Council Assessment Panel Agenda & Reports

**5.1 DEVELOPMENT NUMBER 24016085 – JUDY BARNETT
 - 16 EDMUND STREET, NORWOOD**

DEVELOPMENT NO.:	24016085
APPLICANT:	Judy Barnett
ADDRESS:	16 EDMUND ST NORWOOD SA 5067
NATURE OF DEVELOPMENT:	Partial demolition at the rear of the existing dwelling and removal of the existing garage, construction of a two-storey dwelling addition and verandah, and relocation and repurposing of the existing verandah to become a garage
ZONING INFORMATION:	<p>Zones:</p> <ul style="list-style-type: none"> • Established Neighbourhood <p>Overlays:</p> <ul style="list-style-type: none"> • Airport Building Heights (Regulated) • Historic Area • Prescribed Wells Area • Regulated and Significant Tree • Stormwater Management • Traffic Generating Development • Urban Tree Canopy <p>Technical Numeric Variations (TNVs):</p> <ul style="list-style-type: none"> • Minimum Site Area (Minimum site area is 200 sqm) • Maximum Building Height (Levels) (Maximum building height is 2 levels)
LODGEMENT DATE:	7 Jun 2024

Project	16 Edmund St Norwood
Drawing	SHADOW DIAGRAMS ON JUNE 21st
Date	10 Sept 2024
Scale	NTS
Drawing No.	DA-010c
Contact

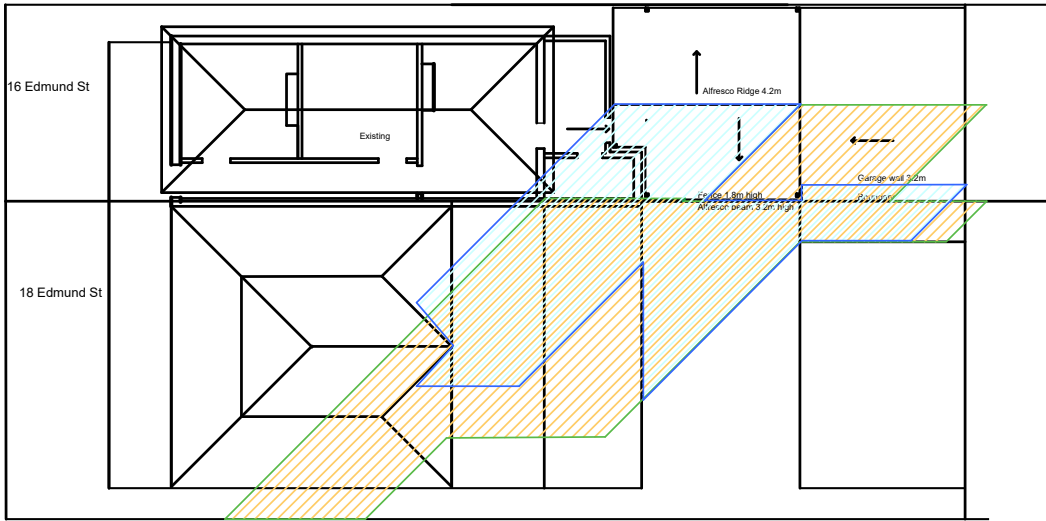
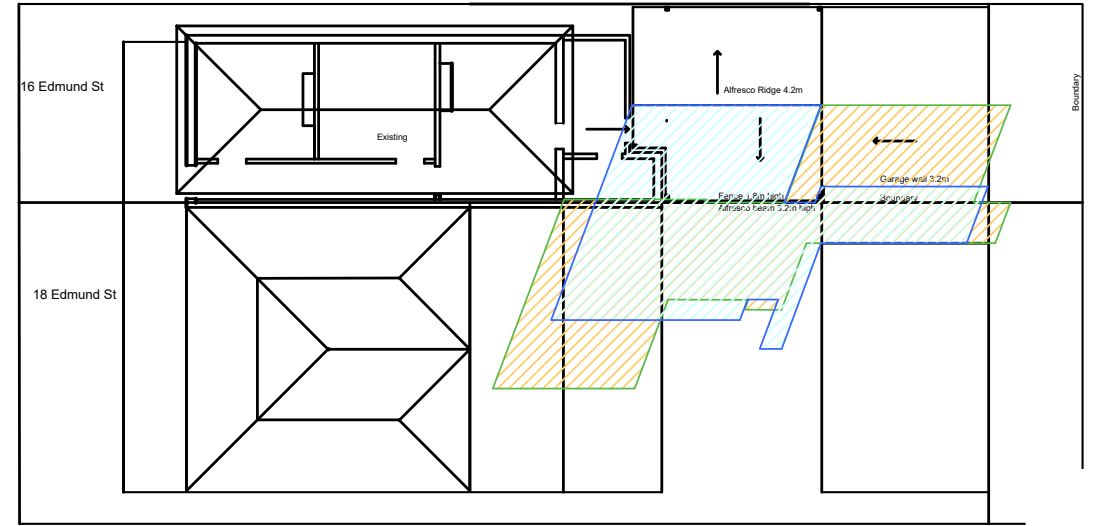
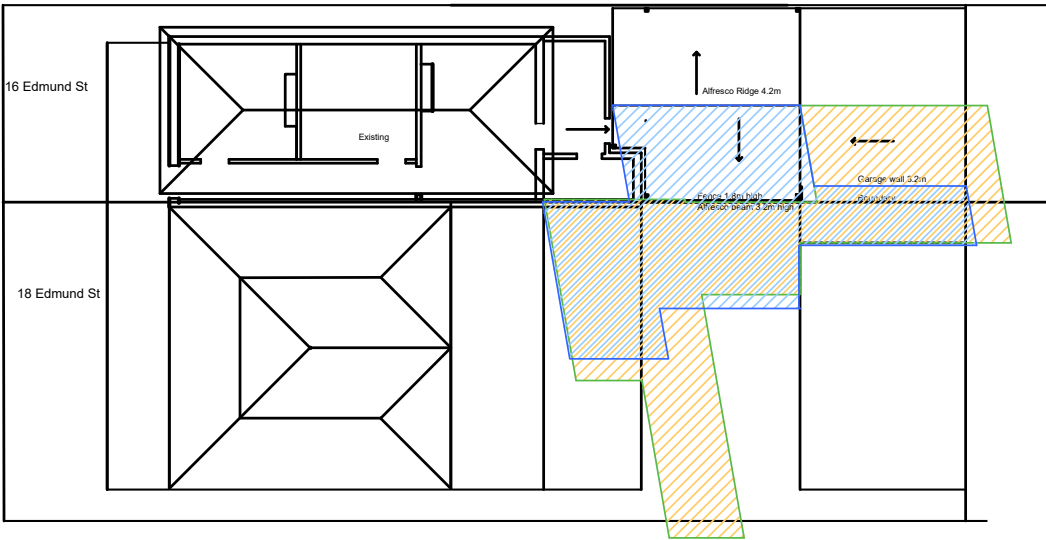
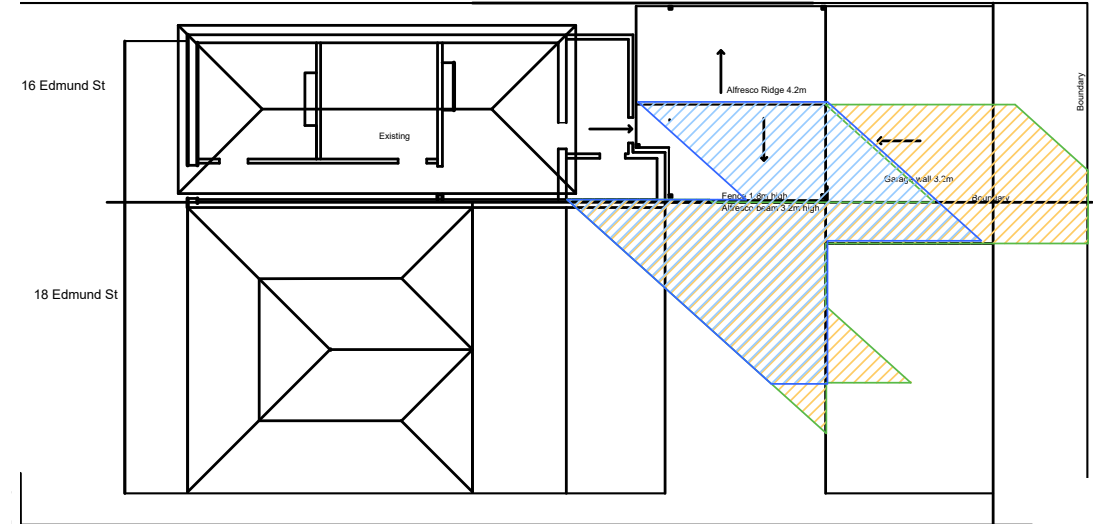
I have sought to verify the shadow diagrams provided in the response to representations, and they appear to be broadly correct. The plan does note that they are not to scale, but by comparison to the scaled plans provided, they do appear to be of an irregular scale (roughly 1:245) They indicate the following areas as receiving direct sunlight:

- 9am- 33.5m²
- 11am- 38.7m²
- 1pm- 20.6m²
- 3pm- 27.9m²

Therefore, while the proposed development would increase the extent of overshadowing, they appear to still meet the guidelines outlined by DPF 3.2 (a) (i)

Project	16 Edmund St Norwood
Drawing	Shadow projection onto #20 rear yard
Date	02 Nov 2024
Scale	1:100
Drawing No.	DA-010i
Contact	Judy Barnett 0432 839 676

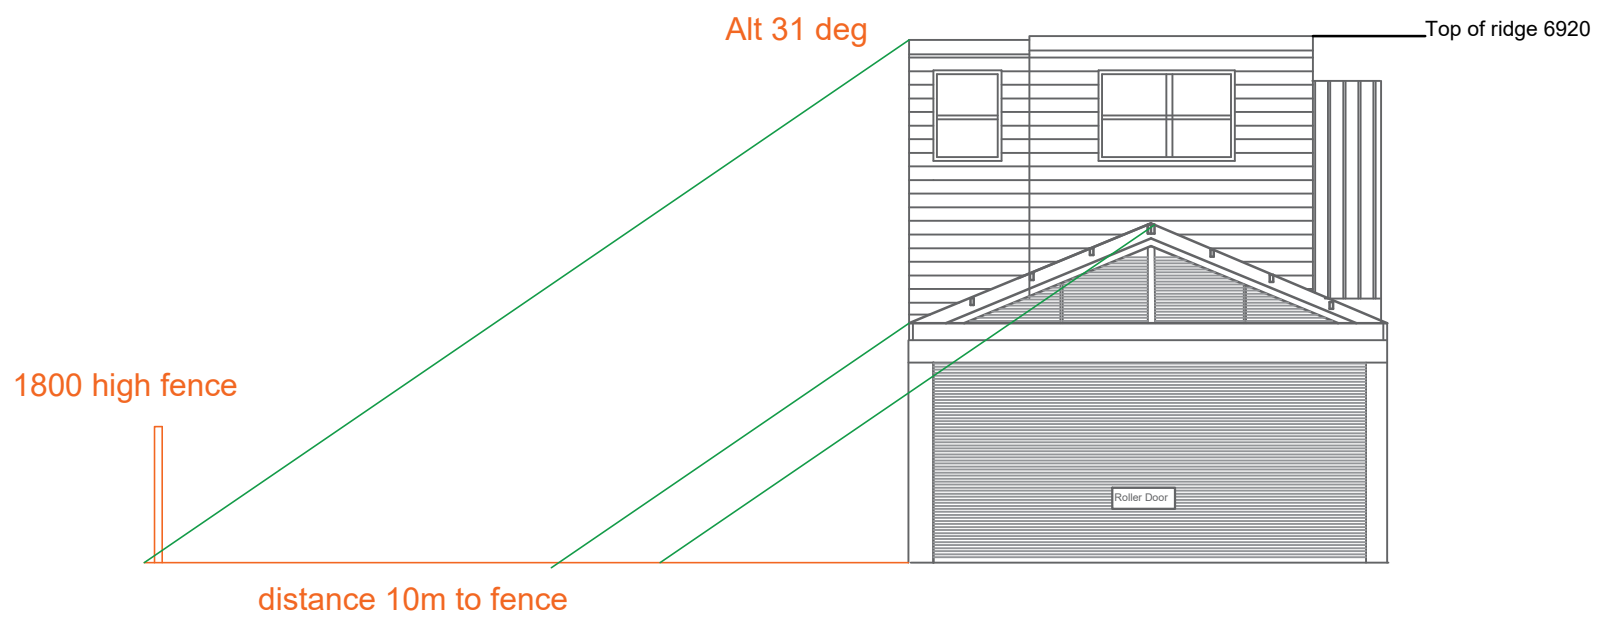
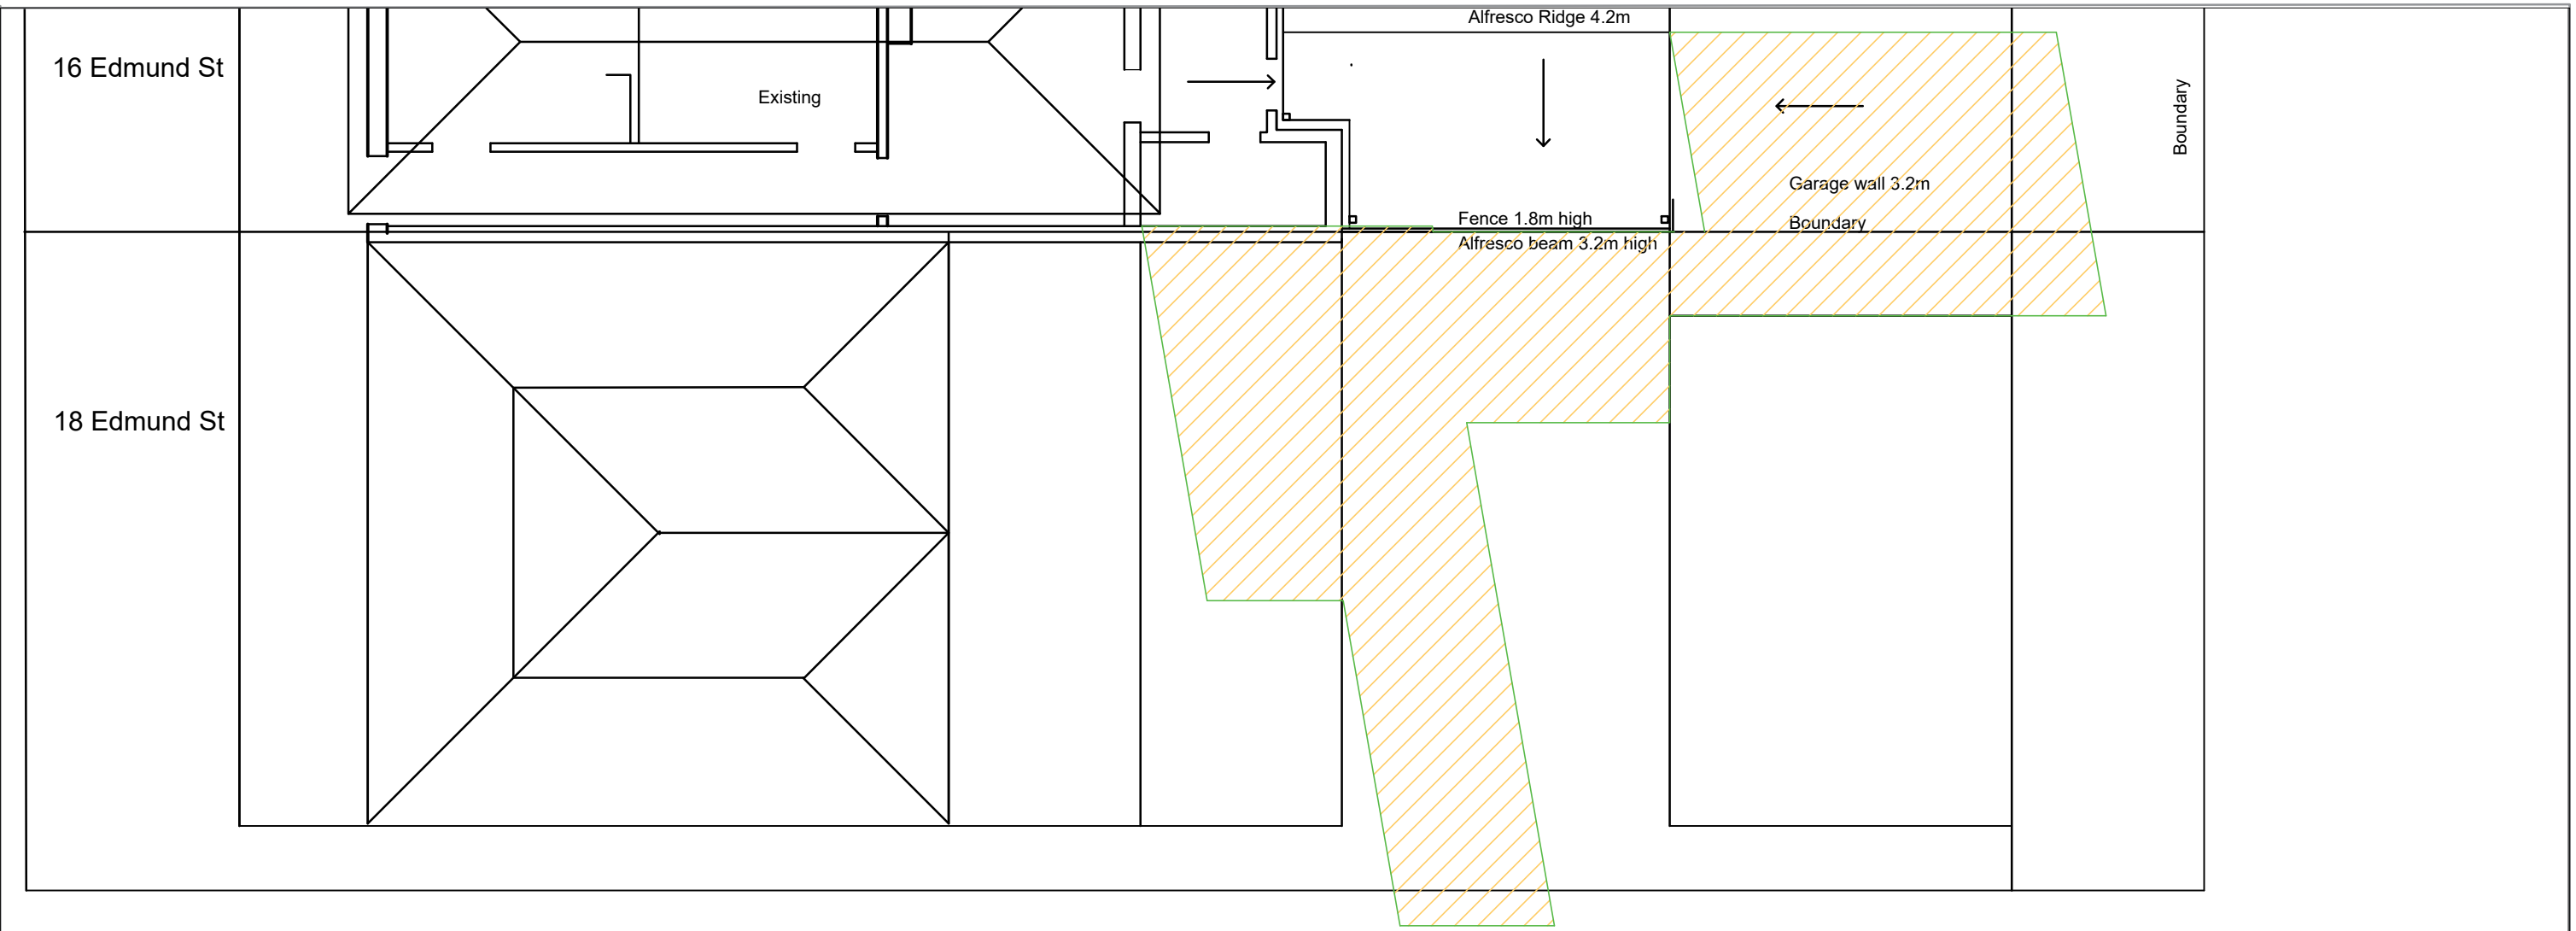
The representor from 20 Edmund St, Norwood raised concerns regarding solar panels. It is evident from the shadow diagrams provided that there will not be any tangible impact on the performance of these solar panels, in line with PO 3.3.
